Access Compliance Report

Public Rights-of-Way

(Curb Ramps)

Intersection ID: 14671	Main Street: DRESDEN_DR_WEST	Cross Street: WOODLAND_DR	Location: S
ADA ID: DCD25A890754	Ramp Type: PerpDiag	Initial Pass/Fail: Fail	Overall Compliance: No
Codes/Mitigation Info/Possible Solution		Field Measurements/Component Compliance

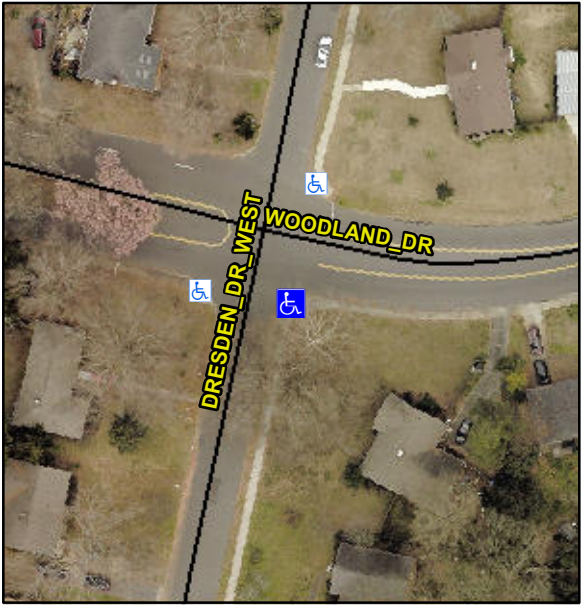
Possible Solutions:						
	Remove & Replace Curb Ramp With Two New Directional Ramps or Equivalent.						
	Surveyor Notes:						
	N/A						
	PROW/ADA:						
	Not Found, R304.5.1						
Street 1 Name	WOODLAND DR						
Stop Condition-Street 2	None						
Street 2 Name	DRESDEN DR WEST						
Stop Condition-Street 1	StopSign						
Total Cost:		\$	3200.00
